AMENDMENTS TO THE DRAWINGS

Fig. 2

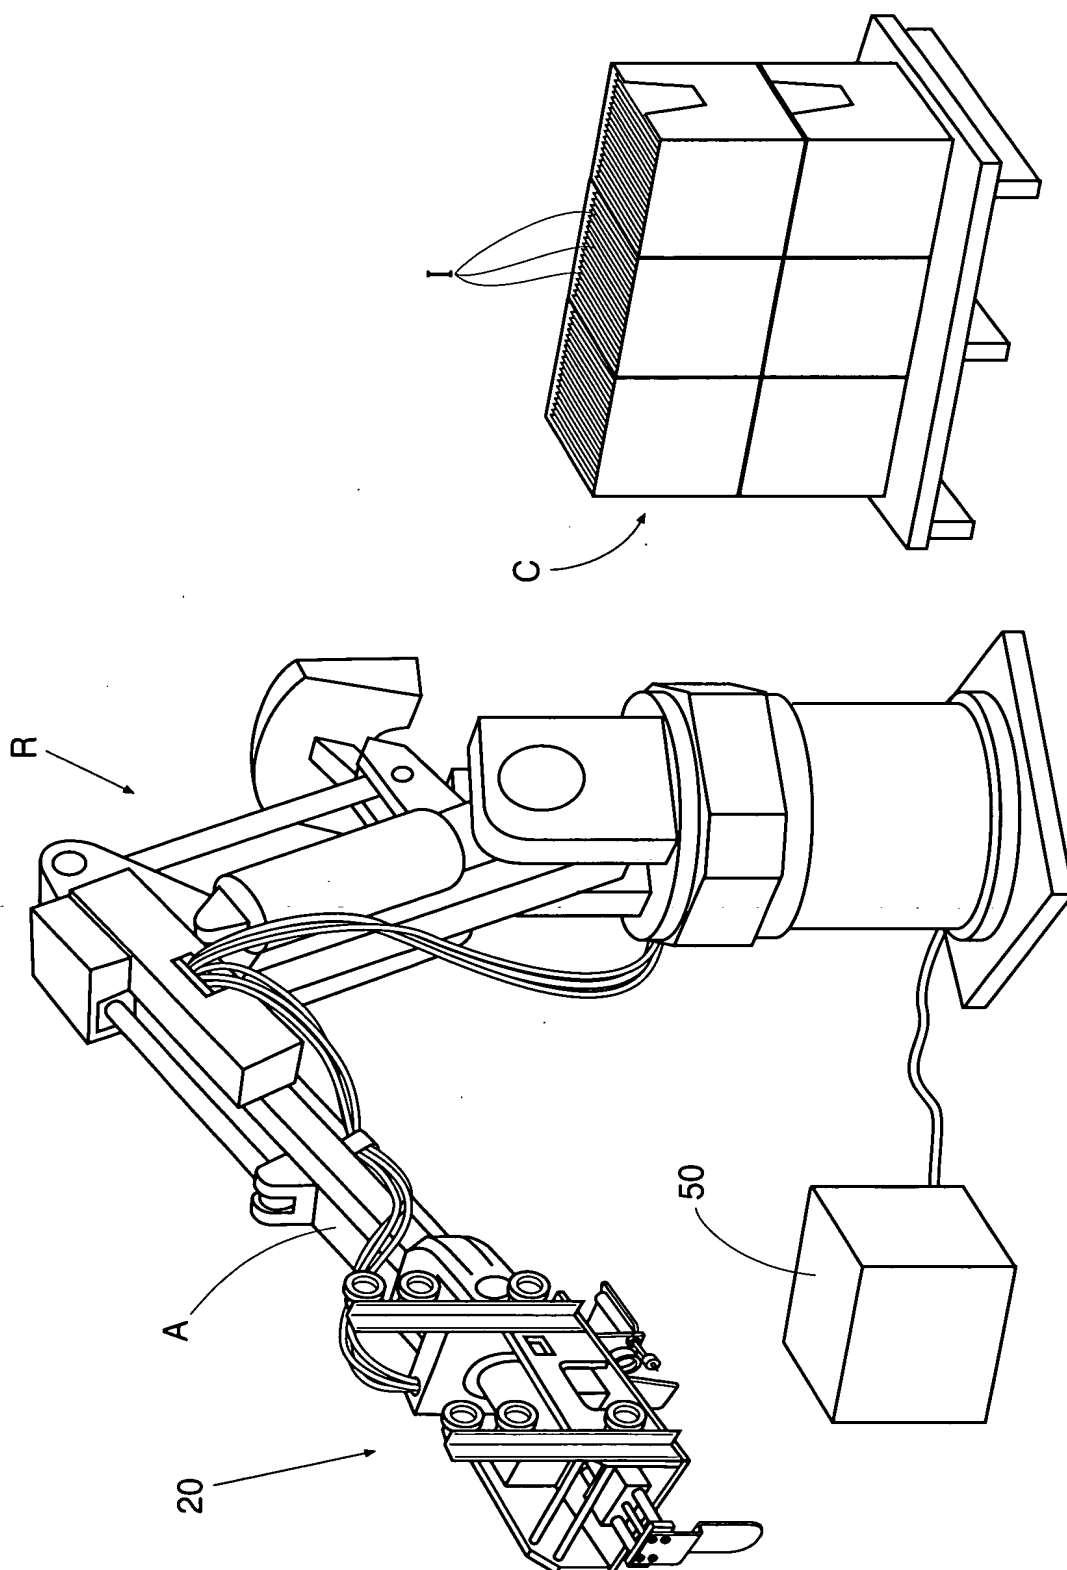
The drawings were objected to as failing to comply with 37 C.F.R. 1.84(b)(5) because they did not include certain reference numerals mentioned in the Specification. For instance, the numeral "50" was improper as it originally referred to the controller (i.e. see Figure 2), the wrist spacer is more properly referred to by the numeral "48" as used throughout the Specification, and particularly page 11.

The enclosed complete set of drawings includes proposed drawing corrections submitted to correct the objection. No new matter has been added. The numerals that have been placed on the drawings correspond to the discussion in the Specification. No new matter has been added to the Specification.
